St Giles Circus - 21 Denmark Street Arcade Design Statment

3 Orms | Project : St Giles Circus | Status : Design Statement | Client : Consolidated | Date : May 2019

Proposed Elevation

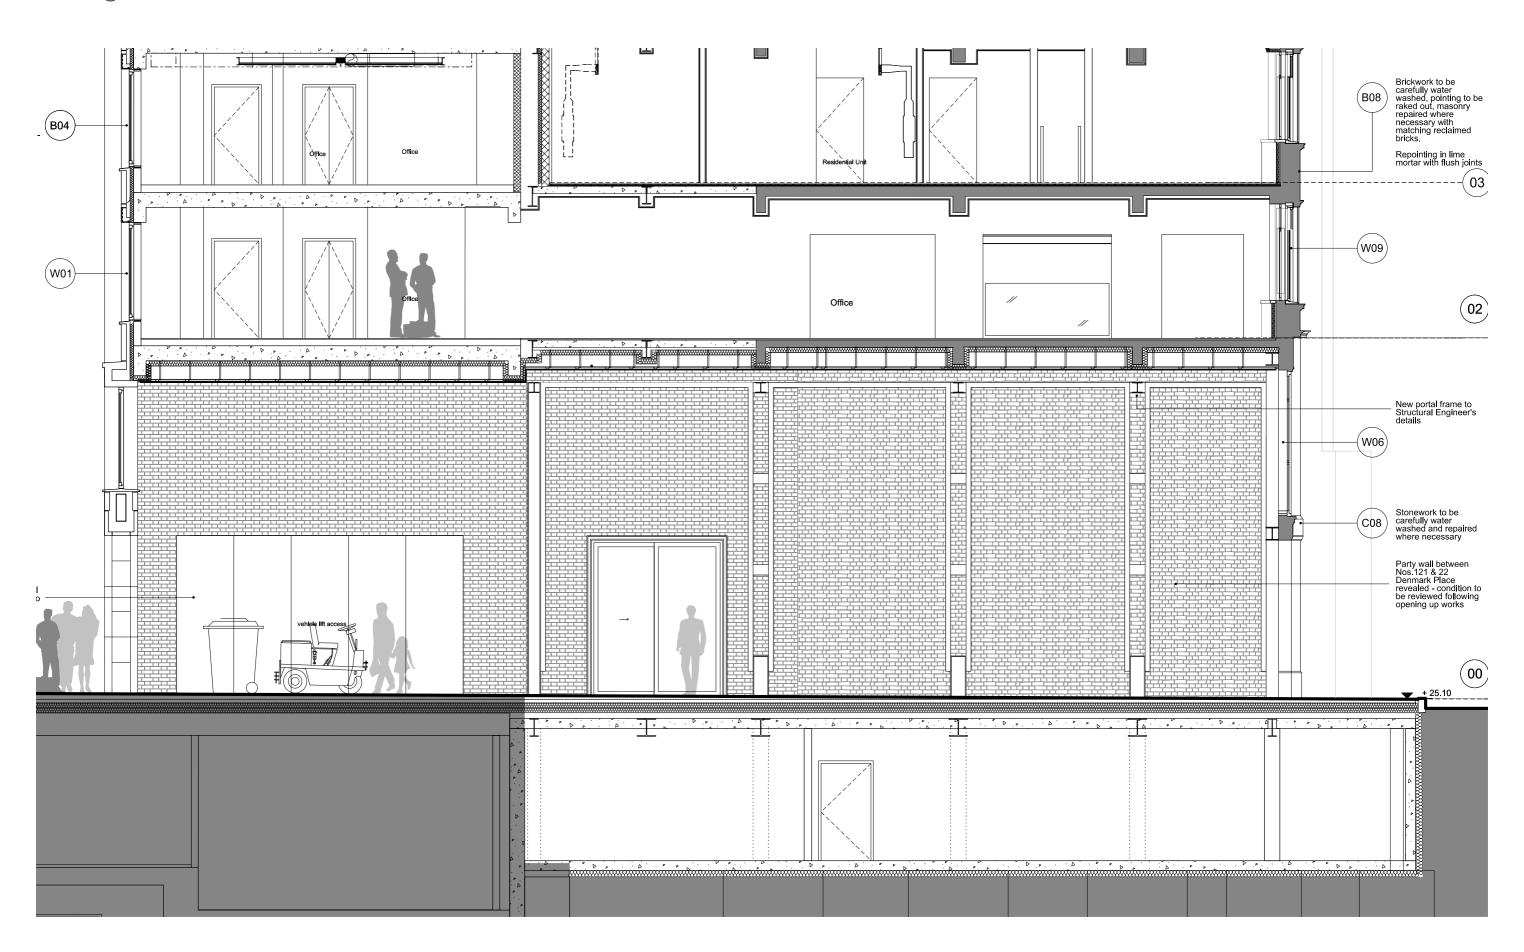
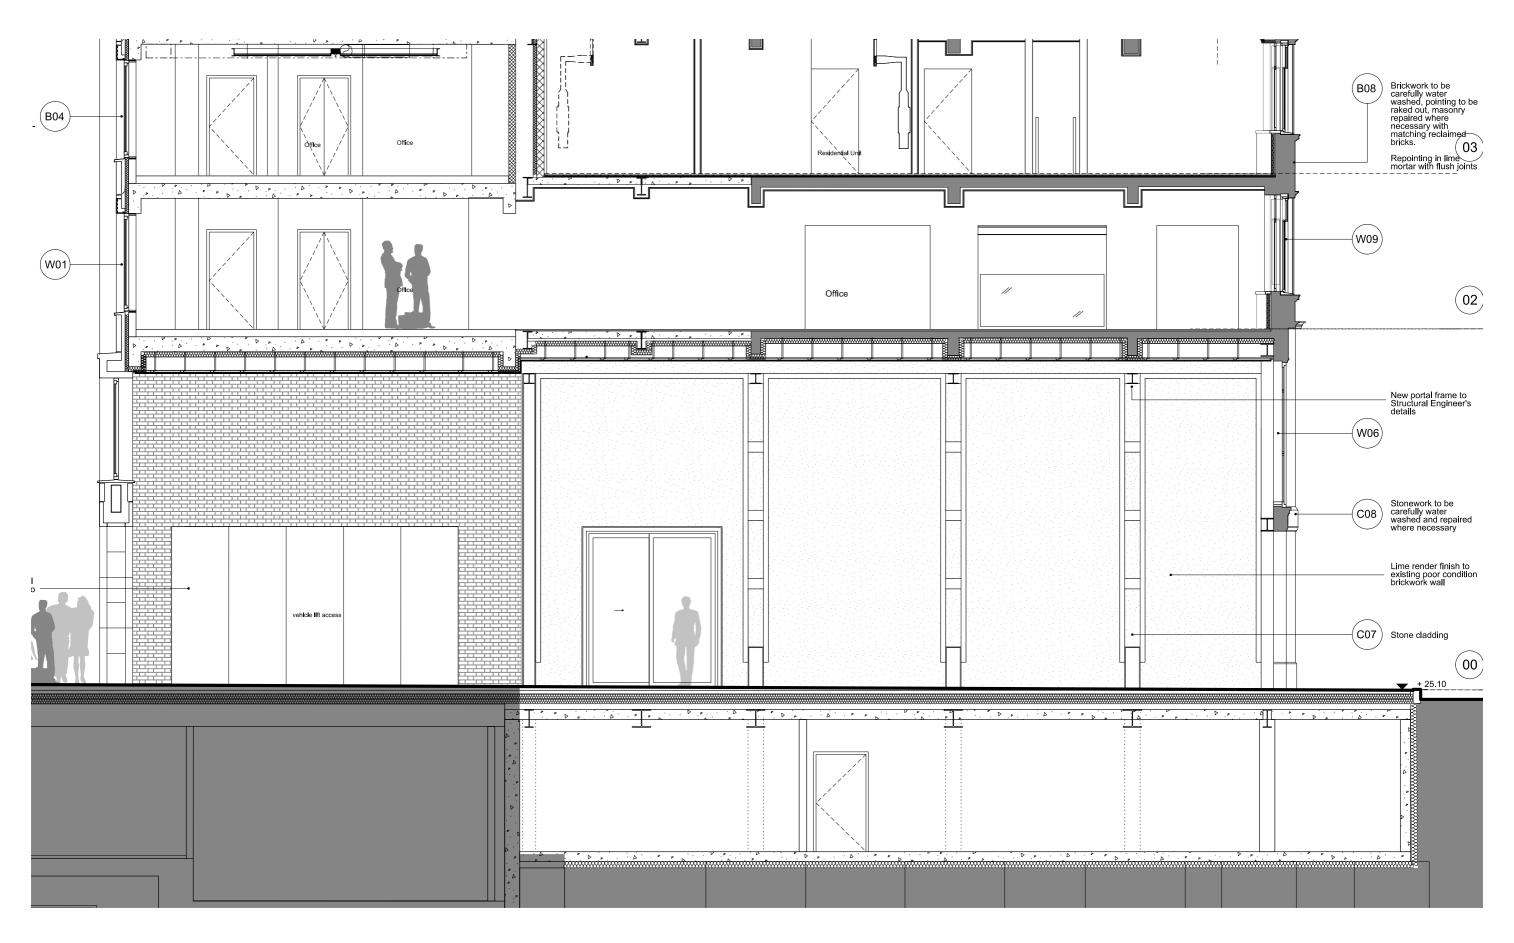
Existing sand cement render has been removed from the existing masonry walls to reveal the existing facing brickwork.

The removal of the render has uncovered several issues with the existing masonry walls.

- Existing masonry is of varying quality
- Existing party wall has different brick types patchworked across the wall due to historic alterations
- Existing masonry has no consistent bonding the bonding is piecemeal and not regonisable as any type

We have reached the conclusion that the existing brickwork cannot be repaired to a level where facing brickwork would provide a positive aesthetic finish.

As a result we propose making the brickwork structurally sound and finishing with a lime render.

Lime Render

Proposed Perspective Lime Render

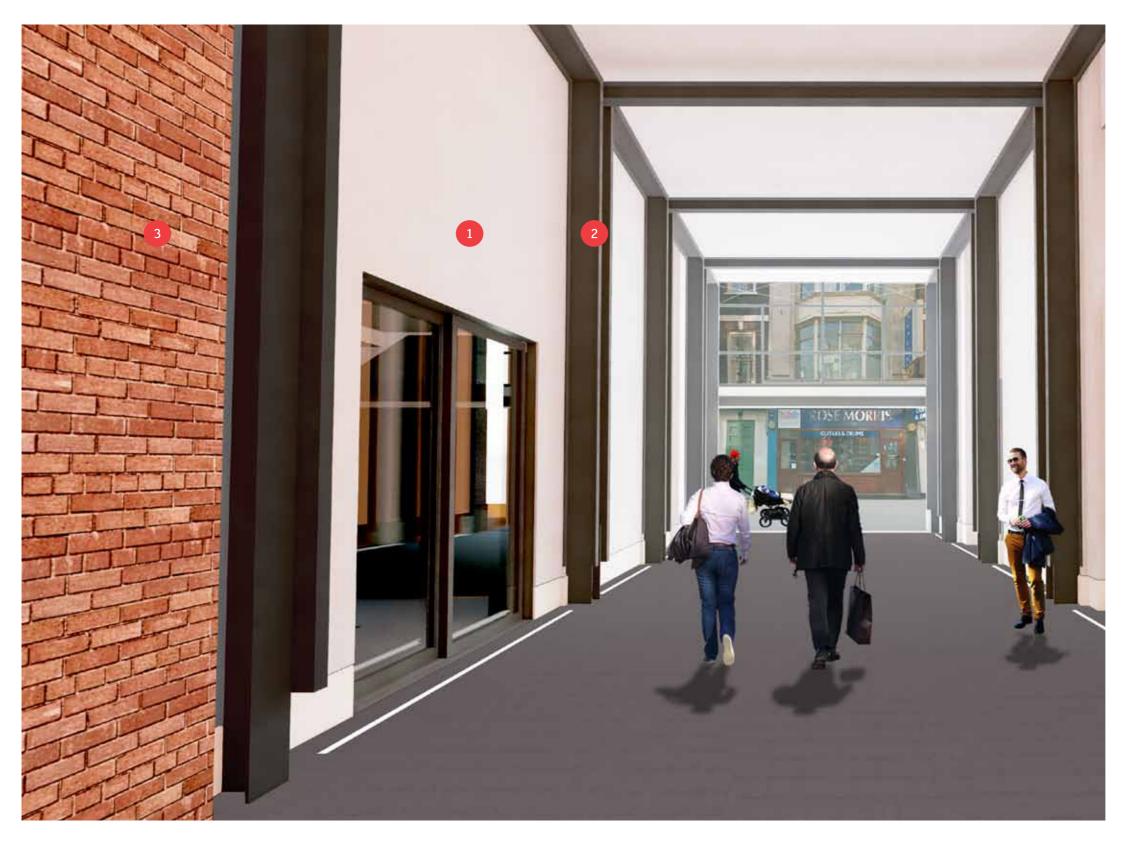
- Render finish to Existing Brickwork
- Exposed structural framing
- Building C Brick Wall

Lime Render
